PROJECT STATUS	RIBA Stage 5
CLIENT	Manchester City Council
PROJECT	Our Town Hall
DRAWING TITLE	Lead roofing and cladding details to access dormer in roof slope WR24
SIZE & SCALE	A1: 1 : 5
DRAWING STATUS	For Construction
JOB NUMBER	236959
DRAWING NO.	OTH-PUR-TH-RF-DWG-A-7100 02
REV

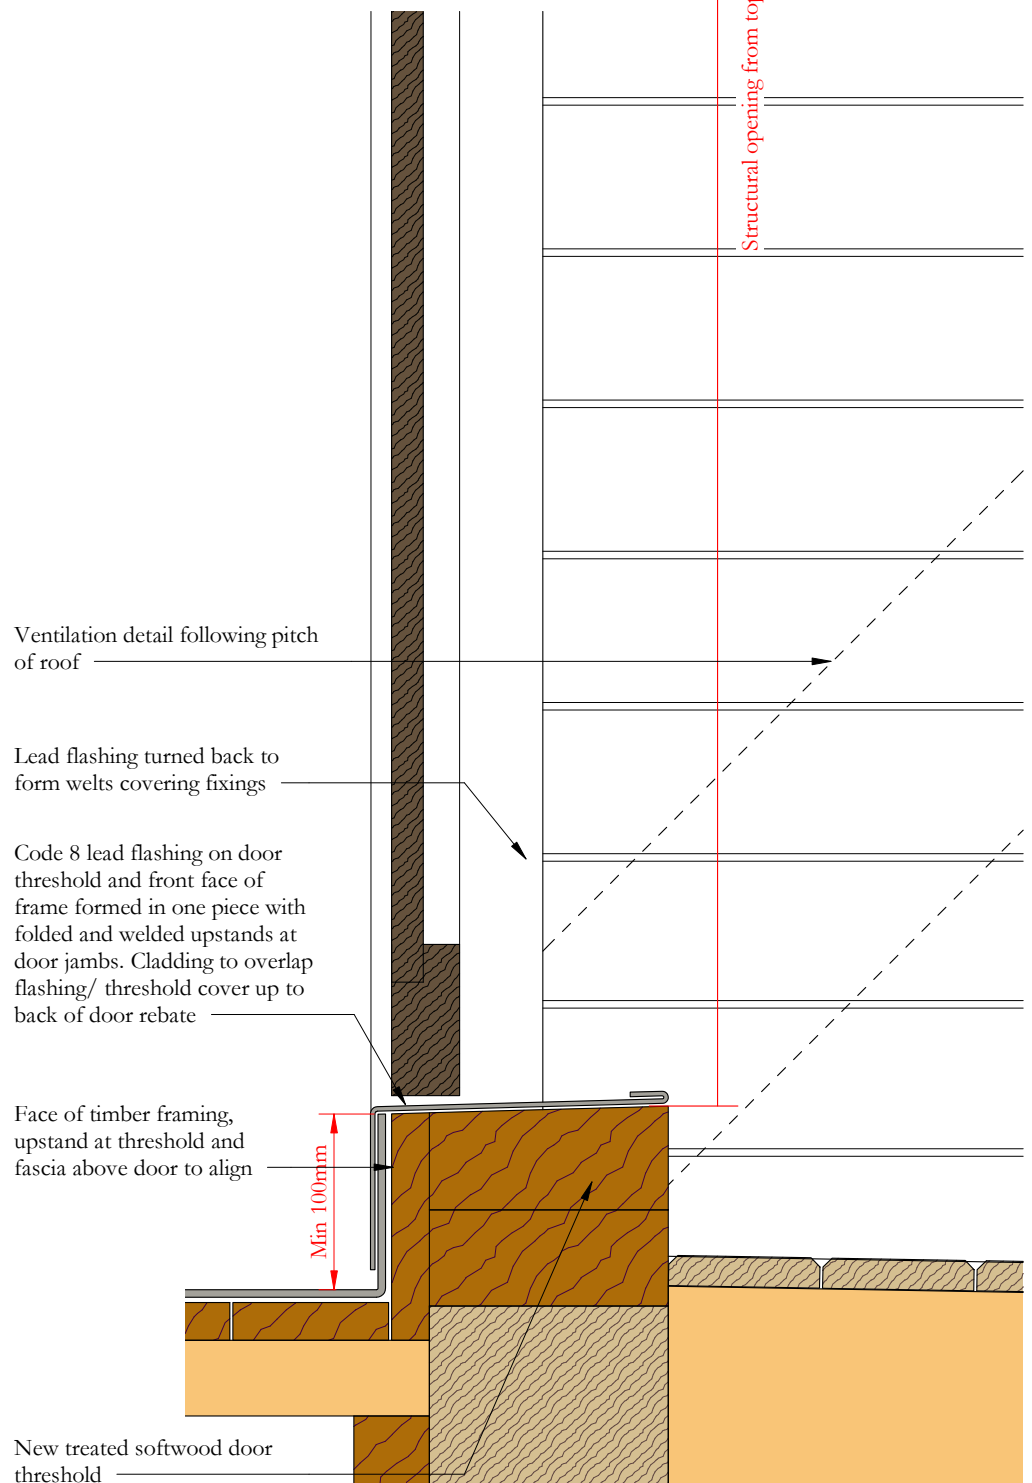
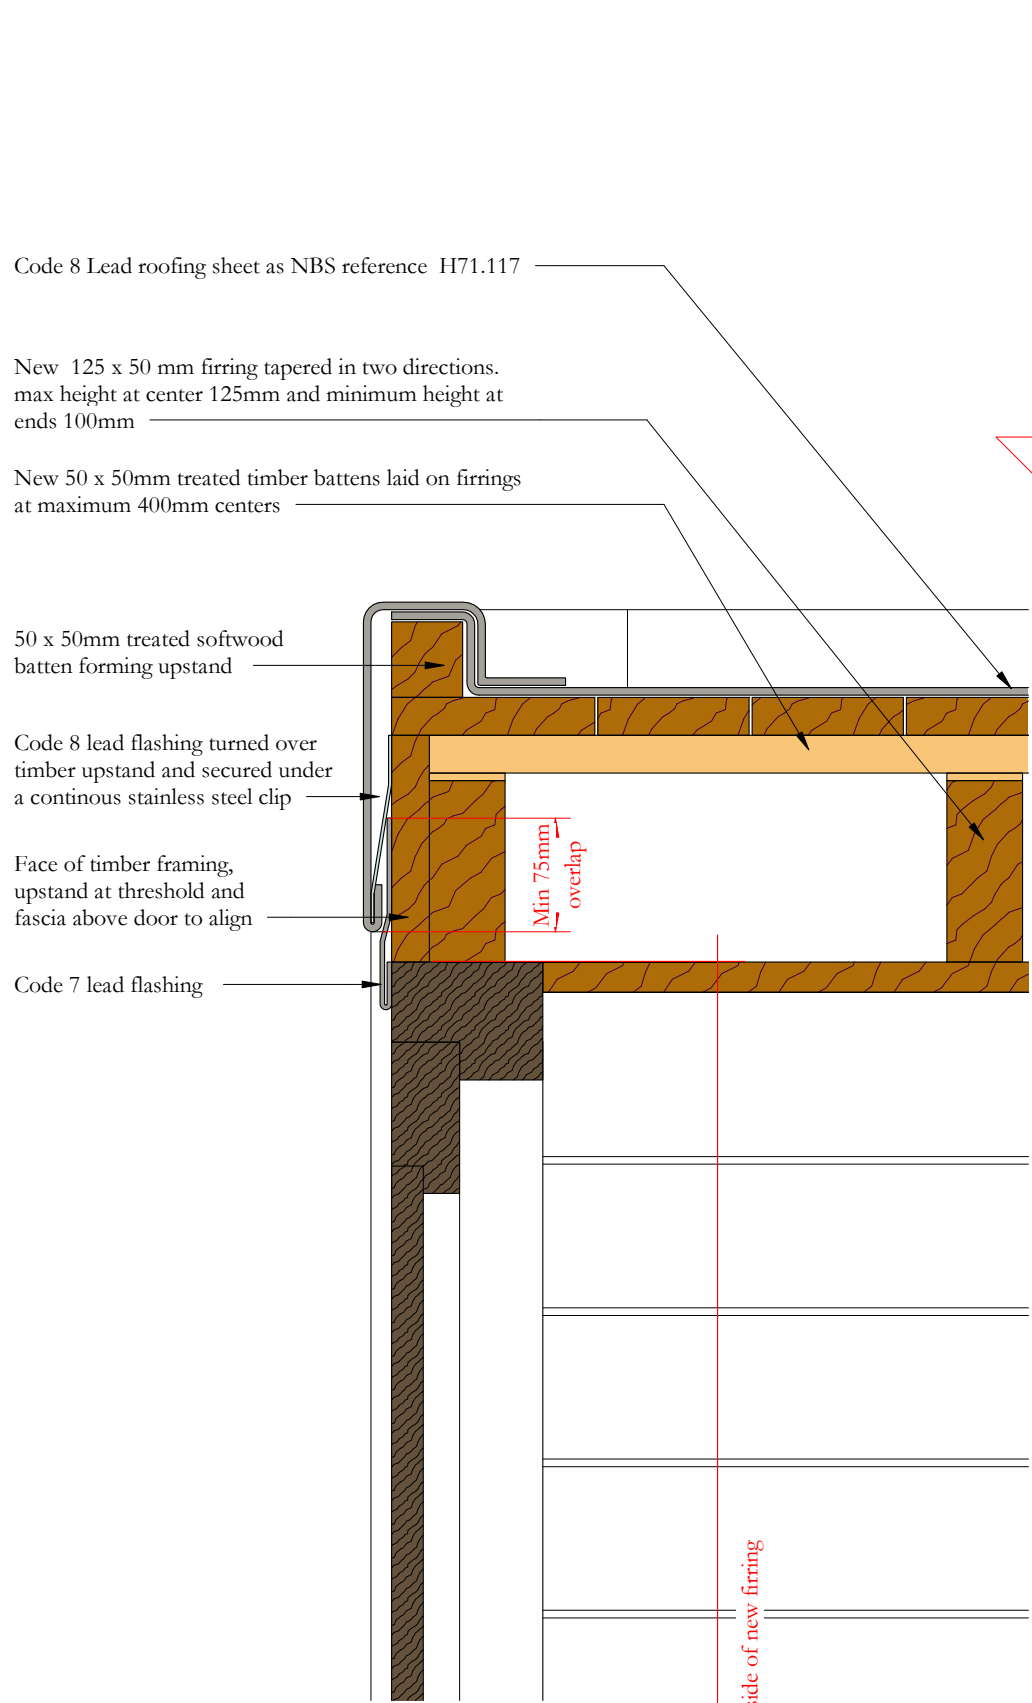
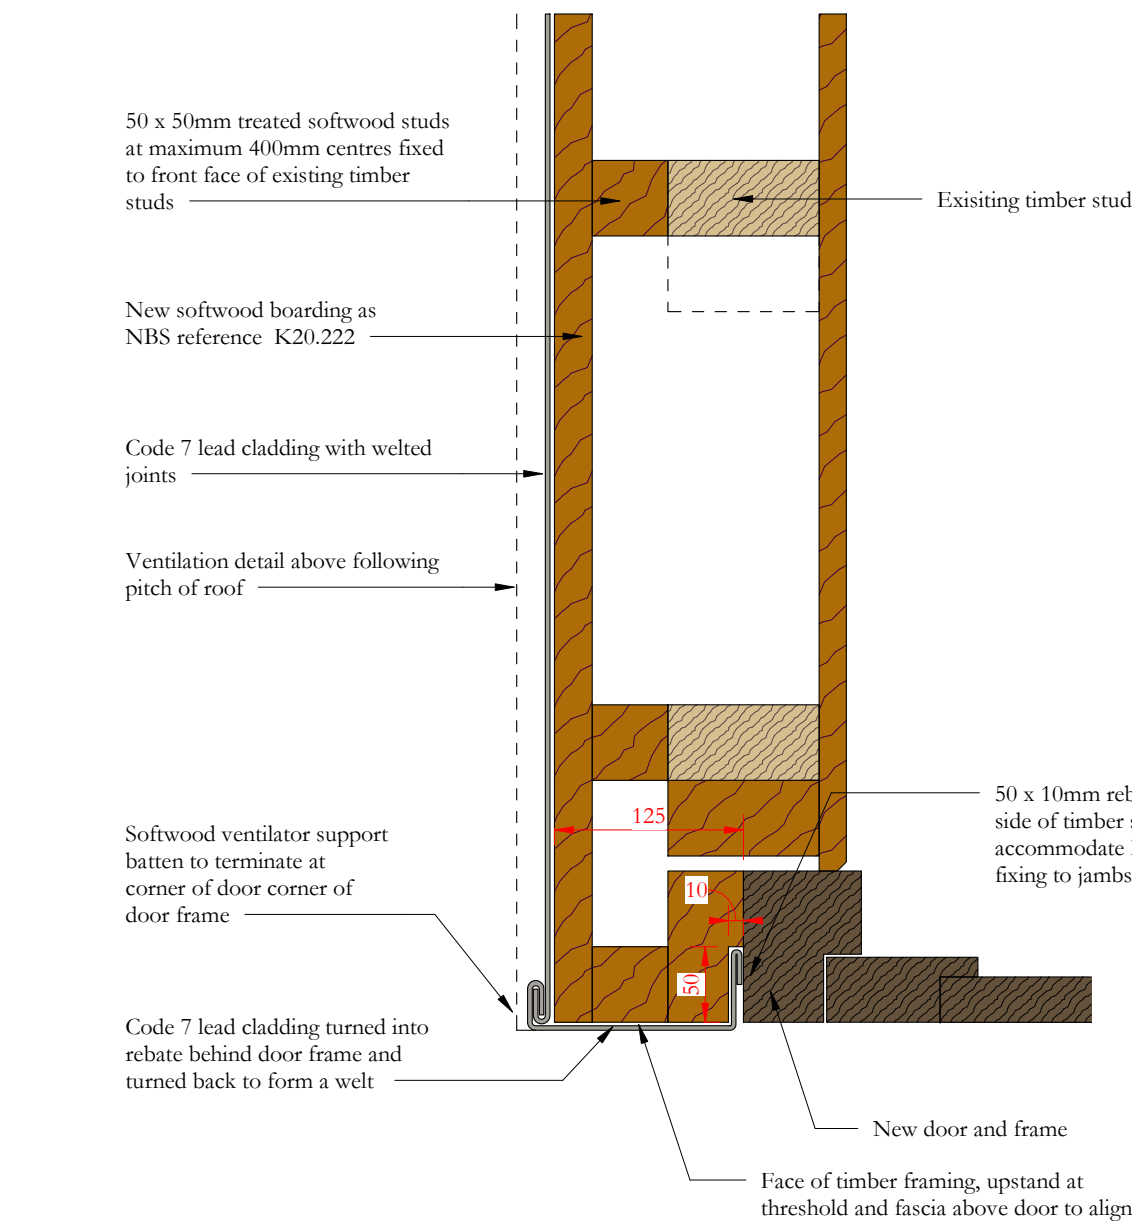
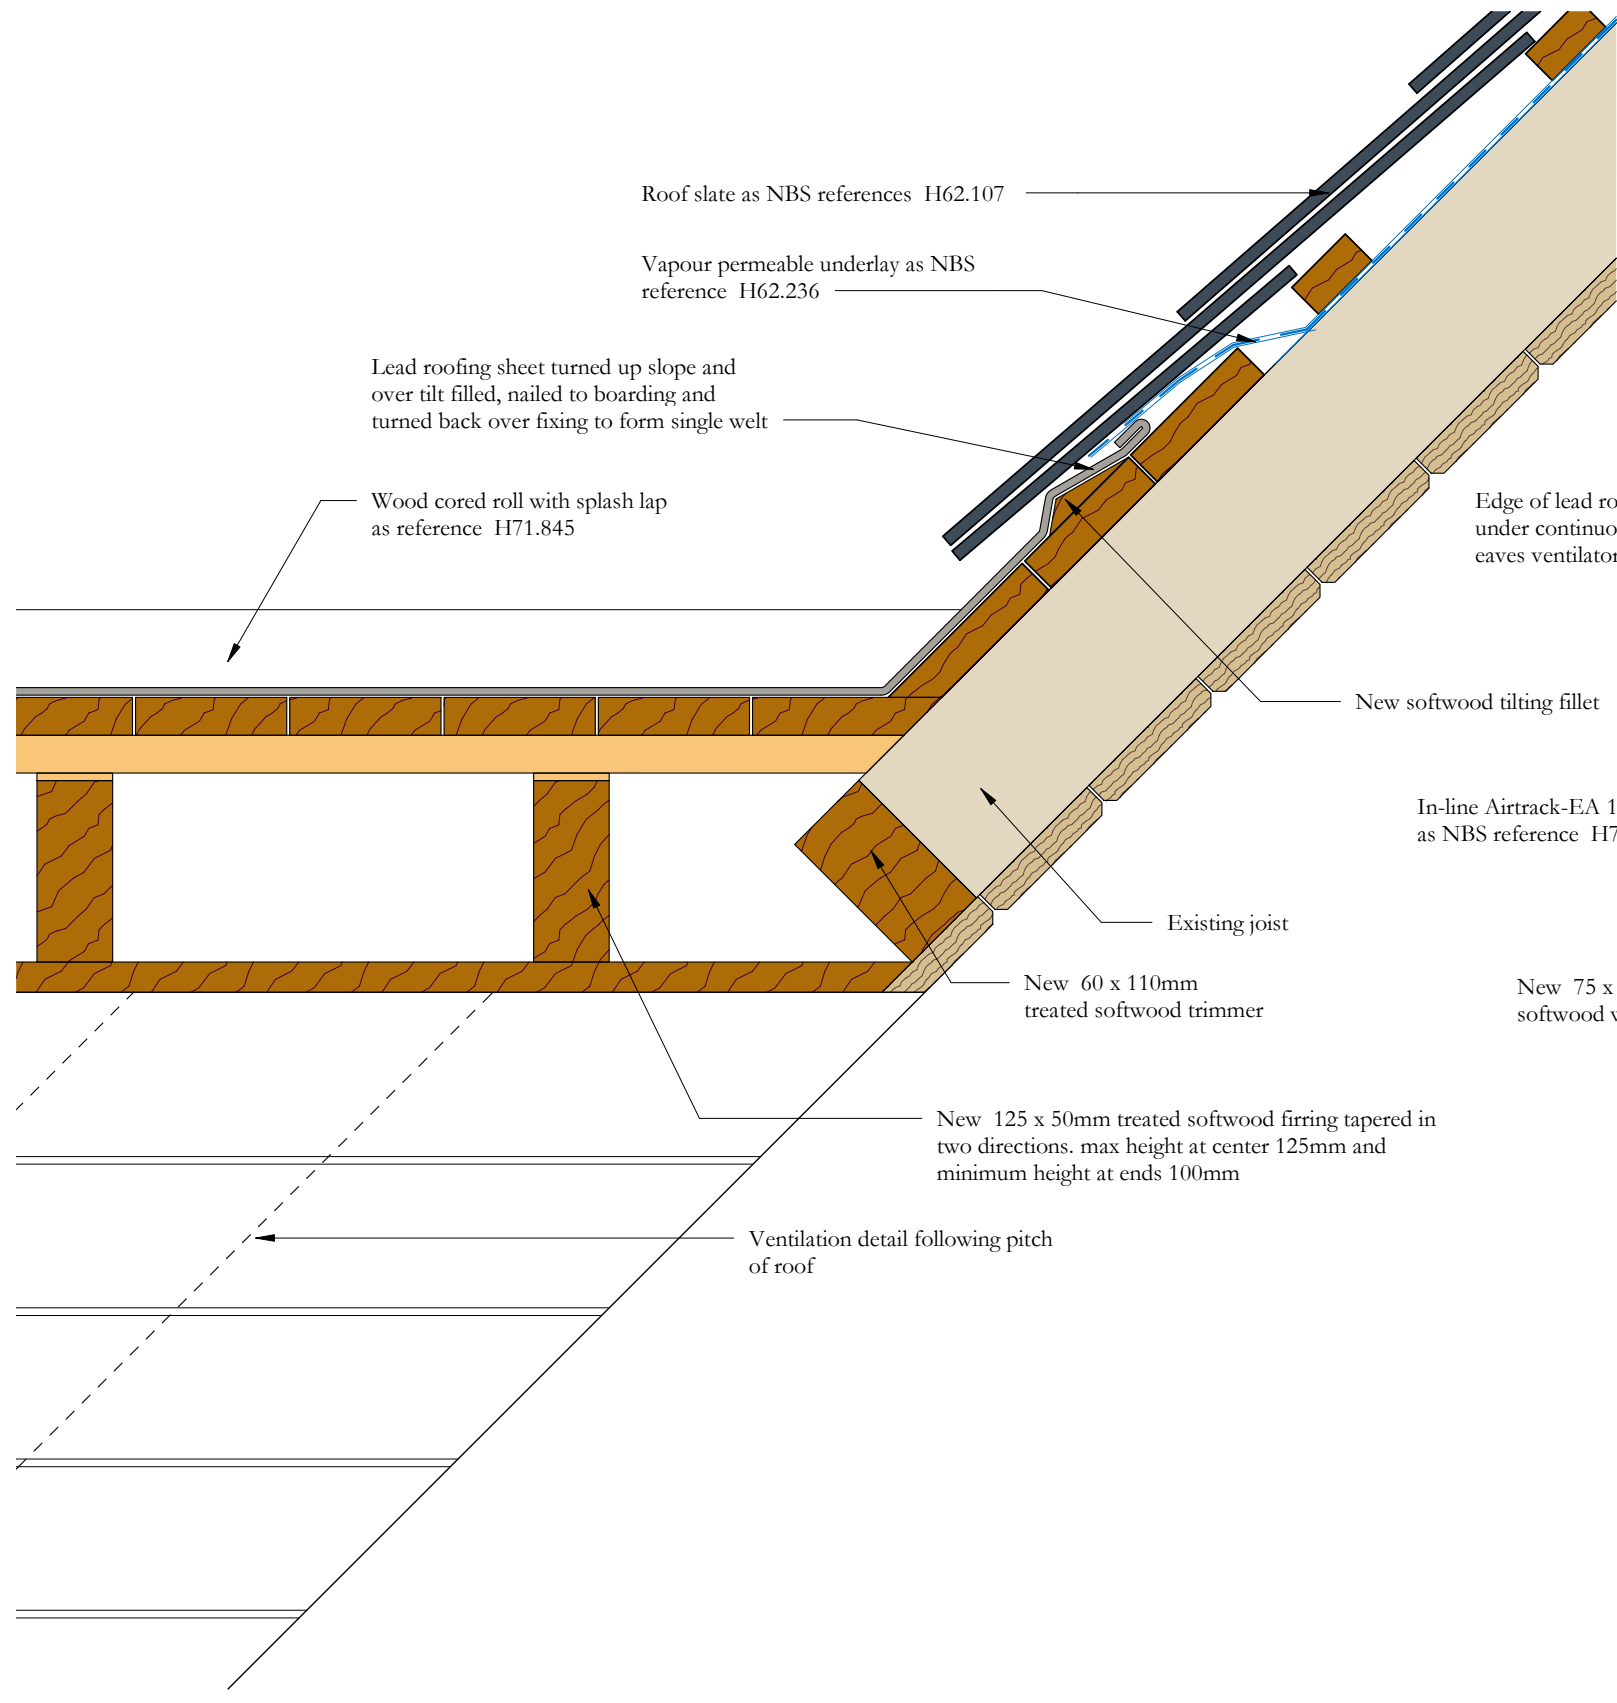
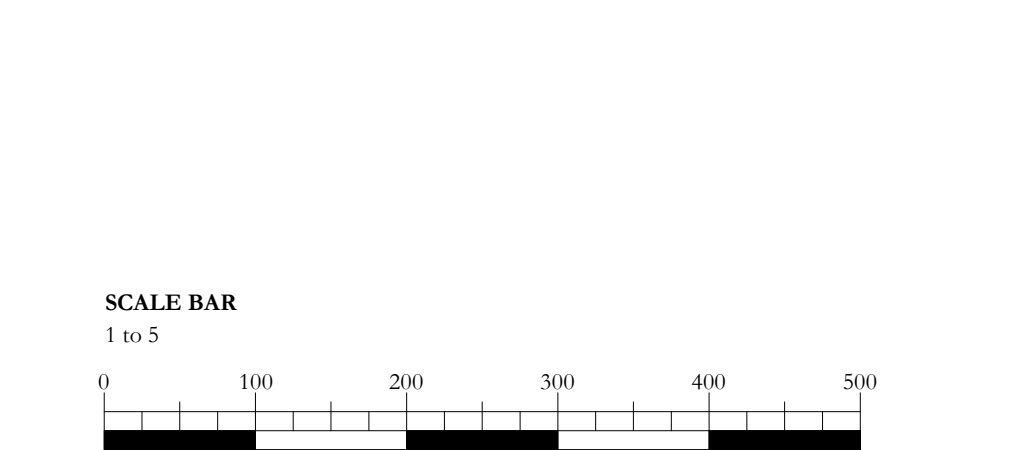
Revision 02: Height of dormer increased to accommodate full height access door. New door and frame indicated. New timber studs shown bolted to existing studs and new roof joists added.

Revision 01: Firrings on roof changed to 50 x 50mm battens following roof slope formed by existing joists. 50 x 50mm vertical battens added to sides of dormer. Door jamb detail added.
